Atsuhiro TOBITA
Serial No. 10/615,783
Response to Office Action dated October 15, 2004

Amendments to the Drawings:

Annotated Sheet Showing Changes

FIG. 1

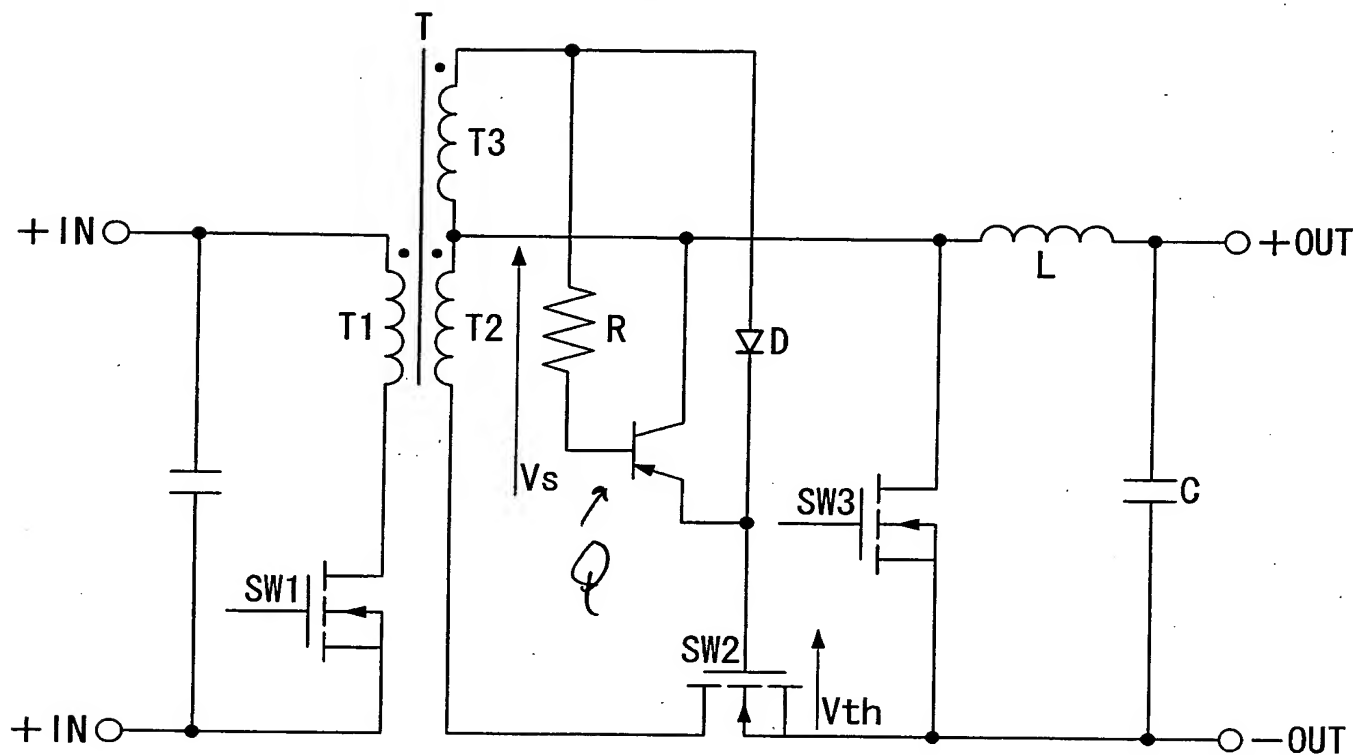
As requested, Figure 2 has been provided with a label --Prior Art--. In addition, the label Q has been added to Figure 1 to reference the auxiliary switch.

The attached sheet of drawings includes changes to Figures 1 and 2. This sheet, which includes Figures 1 and 2, replaces the original sheet including Figures 1 and 2. In Figure 1, a reference element "Q" and a lead line to the auxiliary switch has been added. The legend --Prior Art-- has been added to Figure 2.
